**Subject: MHI's Responses to US-APWR DCD RAI No.35**

Responses to Request for Additional Information No.35 Revision 0

**US-APWR Design Certification**

**RAI NO.: NO.35 REVISION 0**  
**SRP SECTION: 19 – Probabilistic Risk Assessment and Severe Accident Evaluation**  
**APPLICATION SECTION: RG 1.206**  
**DATE OF RAI ISSUE: 7/24/2008**

Figure 3.2.1-1 Large Pipe Break LOCA Event Tree

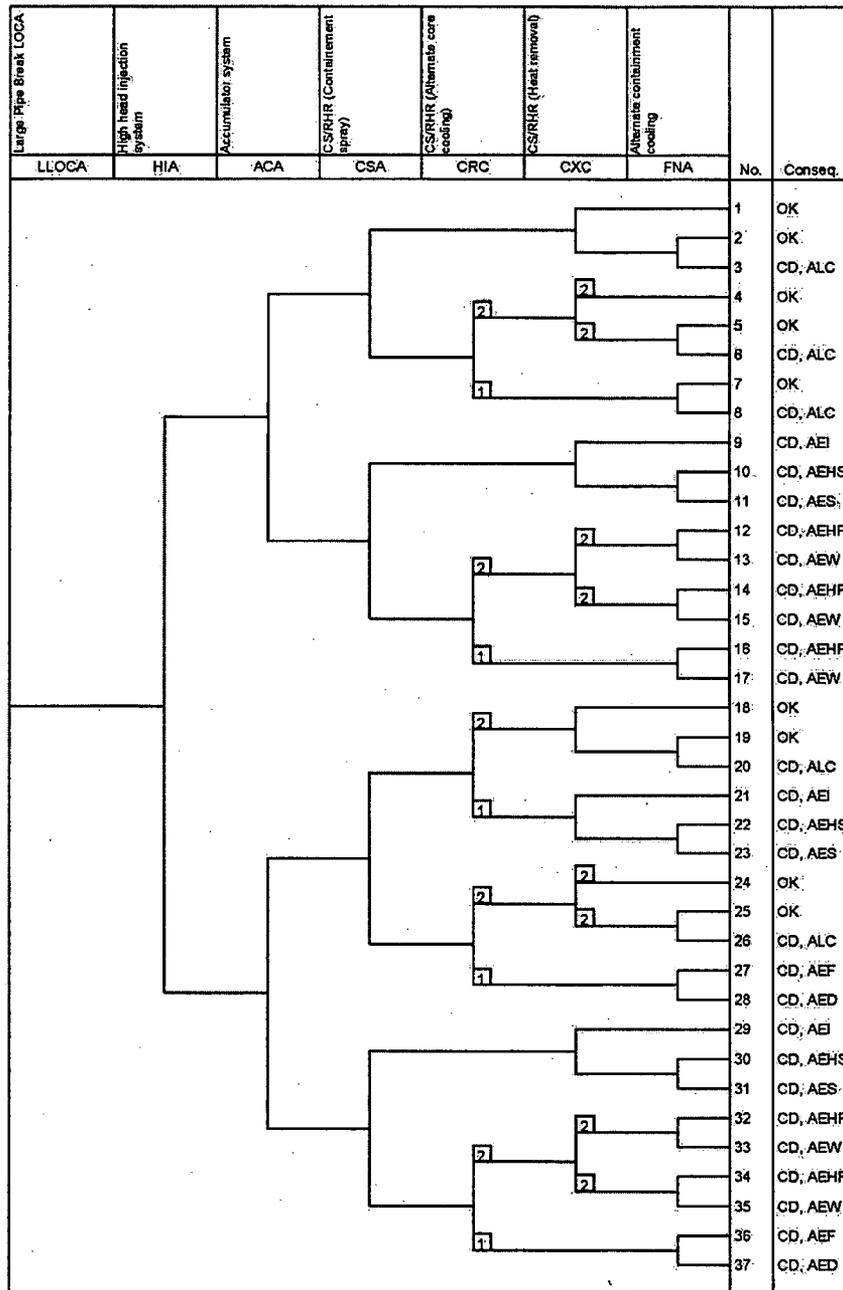
- It appears to be conflicting information between Tables 6A.3-2 and 6A.3-7 and event trees for several initiating events. Tables 6A.3-2 and 6A.3-7 indicate that top event CXA “pump RWST water by CS/RHR, with cooling through the heat exchangers, to containment spray hearers” applies to initiating events, such as LLOCA, MLOCA, SLOCA and SGTR, which is not in agreement with the event trees. Please clarify and revise, as necessary.

- Table 6A.3-2 indicates that top event CRC applies to LLOCA, MLOCA and ELDV initiating events. However, the MLOCA event tree uses top event CRD which is not defined in Table 6A.3-2 or anywhere else. Event tree ELDV is not defined or discussed in the PRA. Please clarify and revise, as necessary.

The relation between ET headings and FT headings of LLOCA are described in Table 3.2.1.2-1 and the event tree in Figure 3.2.1-1. These tables and figures will be incorporated in the revised PRA technical report. Tables in Attachment 6A will be entirely reviewed and amended to be consistent with the table 3.2.4.2-1.

Figure 3.2.4-1 Very Small Pipe Break LOCA Event Tree

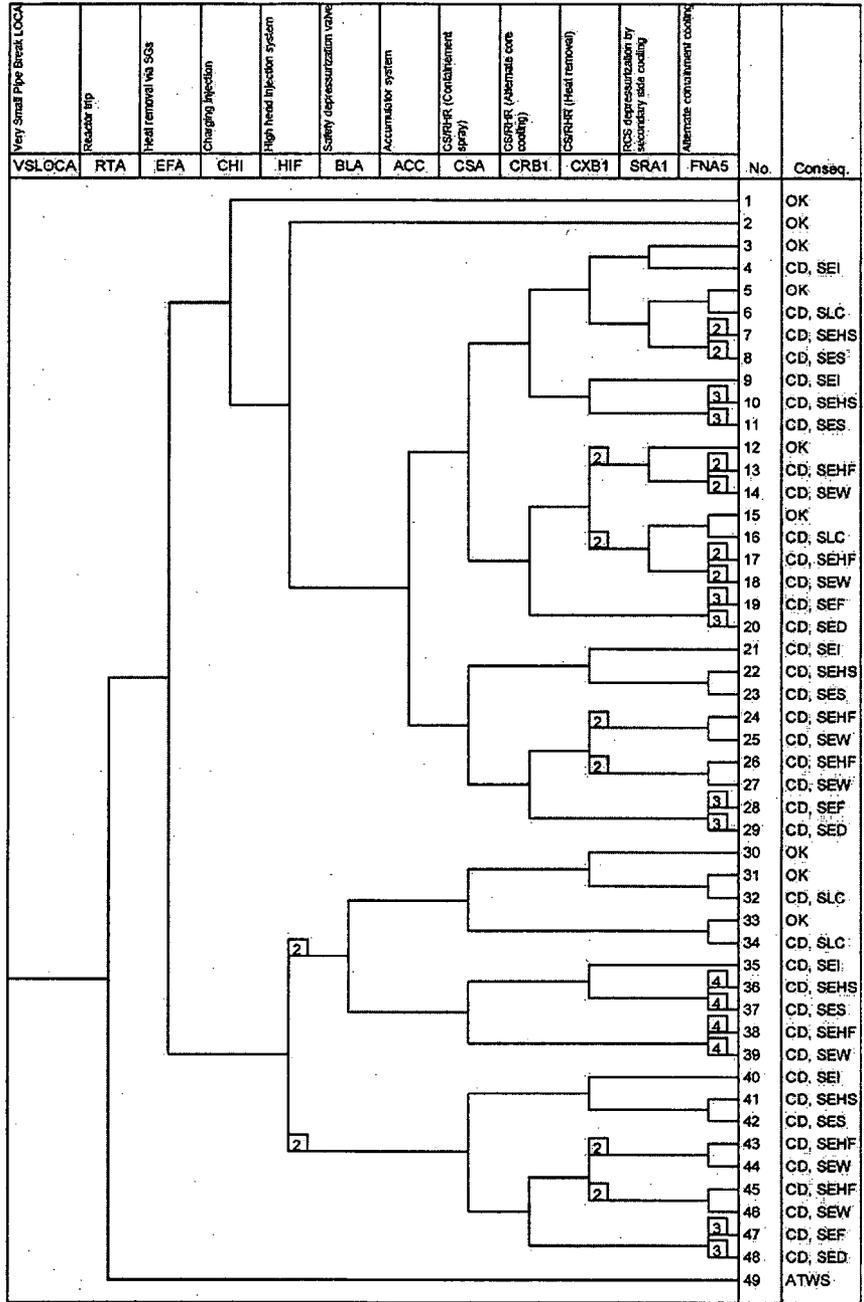
- The top events CRB1 and CXB1 are used in the VSLOCA event tree, which are not defined. Please explain how are these events different from events CRB and CXB defined in Tables 6A.3-2, 6A.3-4 and 6A.3-8.

The relation between ET headings and FT headings of VSLOCA are described in Table 3.2.4.2-1 and the event tree in Figure 3.2.4-1. These tables and figures will be incorporated in the revised PRA technical report. Tables in Attachment 6A will be entirely reviewed and amended to be consistent with the table 3.2.4.2-1.

Figure 3.2.5-1 Steam Generator Tube Rupture Event Tree

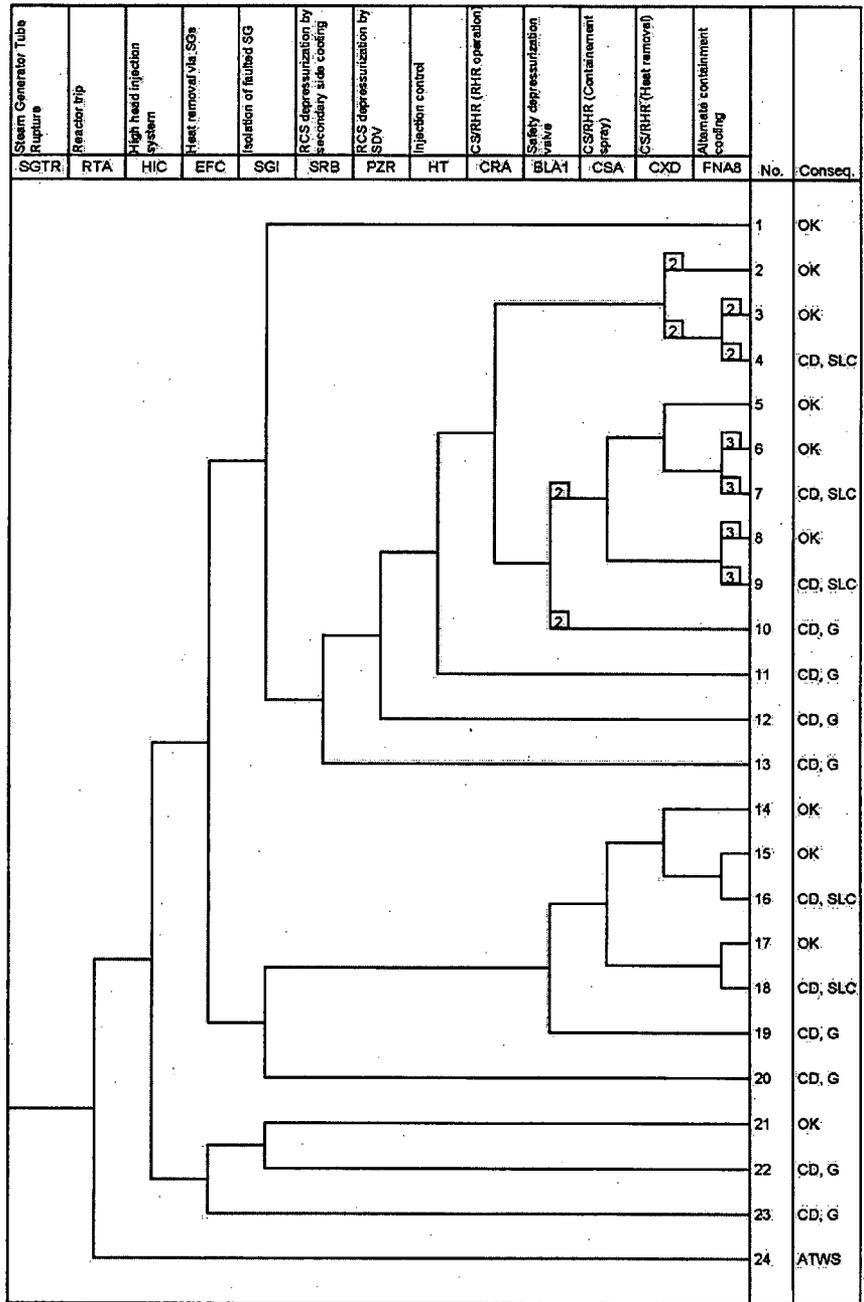
- Table 6A.3-2 indicates that both top events CXA and CXD are applicable to SGTR sequences only. However, the SGTR event tree shows only top event CXD for which no description is provided in Section 3.2.8.2 (a description of top event CXA is provided in Section 3.2.8.2). Please clarify and revise, as necessary.

- Top events CRA and CXD apply to SGTR accident sequences according to the information provided in Tables 6A.3-2, 6A.3-6 and 6A.3-10. However, there is no

discussion how these two events are different and under what conditions each of them apply. Please explain.

The relation between ET headings and FT headings of SGTR are described in Table 3.2.5.2-1 and the event tree in Figure 3.2.5-1. These tables and figures will be incorporated in the revised PRA technical report. Tables in Attachment 6A will be entirely reviewed and amended to be consistent with the table 3.2.5.2-1.

Figure 19-83.2 Alternate core injection

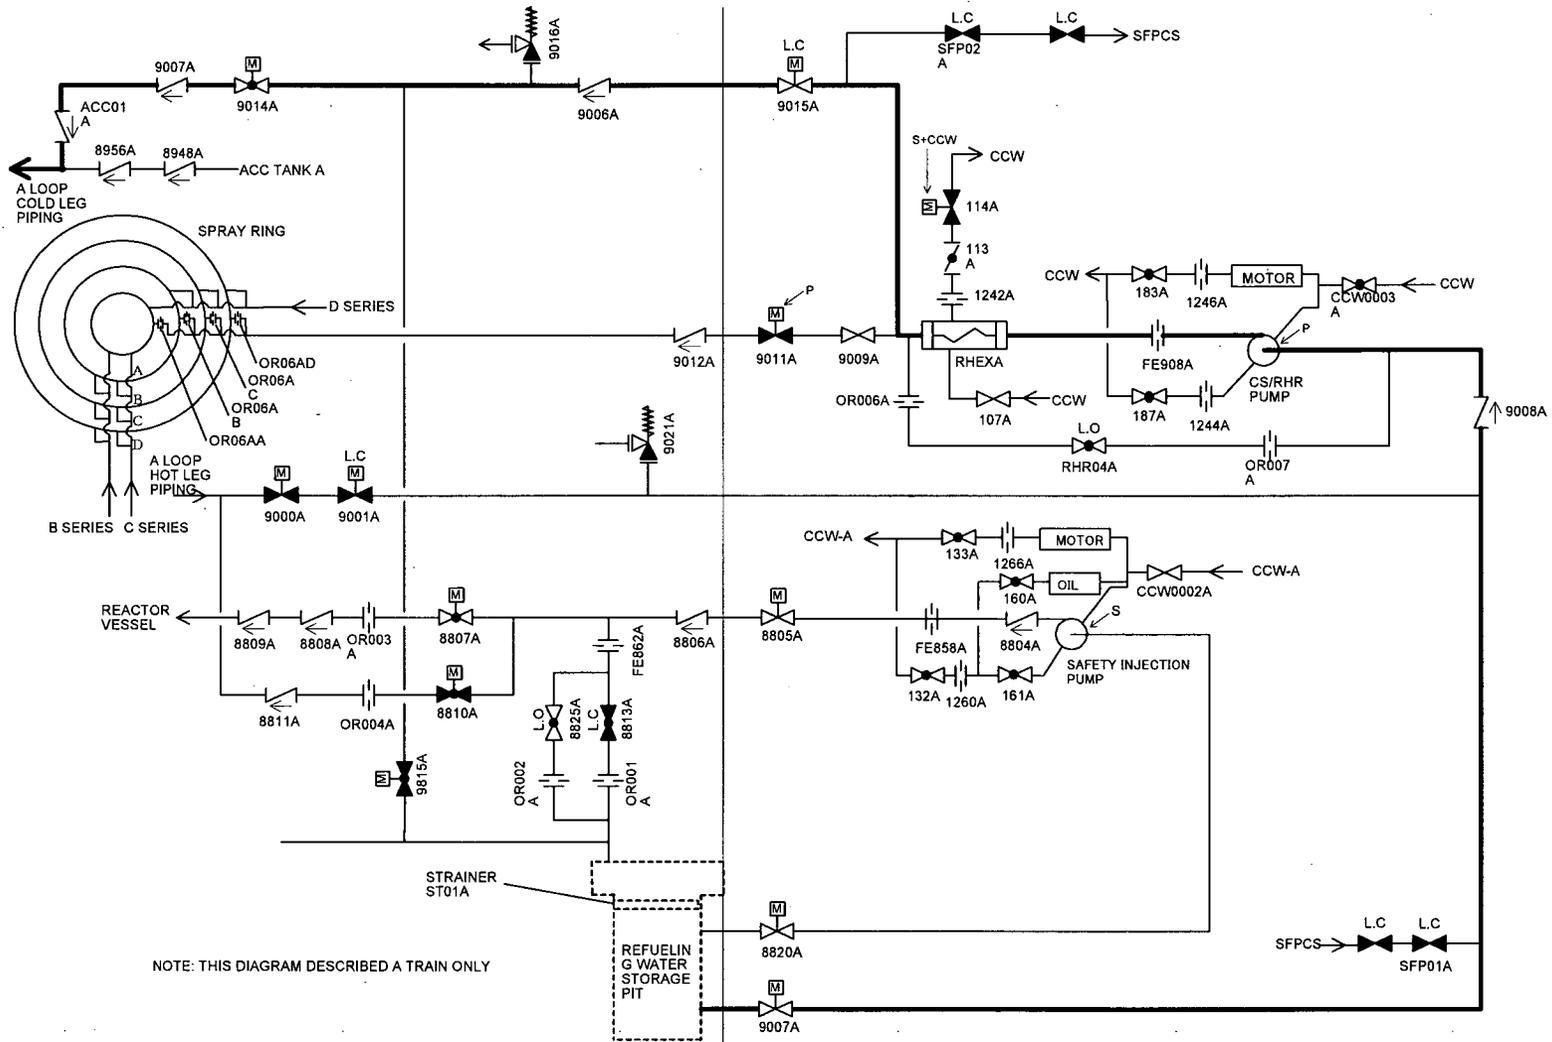
Several sequences in many event trees indicate that both containment spray (top event CSA) and alternate core injection by CS/RHR through the cold legs (e.g., top events CRB and CRB1) can be successful in same sequence (e.g., LLOCA sequence #18 and VSLOCA sequence #3). Since event CRB requires closing the containment spray header isolation valves (Table 6A.3-4), it appears that containment spray ceases its operation when alternate core injection is activated by the operator. Please state the key assumptions that were made and explain the basis of the assumed mission time for the containment spray function and the time window for successful switching to alternate core injection.

In the US-APWR PRA for operations at power, containment spray system is modeled having two functions, i.e. ordinary containment spray function and alternate core cooling function. Containment spray system consists of 4 independent trains and these two functions can be achieved simultaneously. This alternate core cooling function is briefly described in DCD Subsection 19.2.5. Function and mission time of these functions are described below.

The CS/RHR pumps have function to supply RWSP water into the cold leg piping by manually switching over the CS/RHR pump lines to the cold leg in case of high head injection system failure.

The time from onset of accident till core uncover is evaluated as approximately 30 minutes in Case 1.4-1 of Chapter 5 Attachment A Table 5A.1.4-1 of the PRA technical report, which assumes LOCA event with 8 in. diameter breach under failure of both high head injection system and alternate core cooling. From this evaluation result, it is considered that core damage can be prevented if alternate core cooling is achieved within 30 minutes after onset of LOCA. As stated in Chapter 5 Attachment A Table 5A.1.5-1, the success criterion of alternate core cooling to prevent core damage is 1 out of 4 cold leg injection. Hence, in the actual operation, switchover of two CS/RHR trains from containment spray line-up to alternate core cooling line-up is expected.
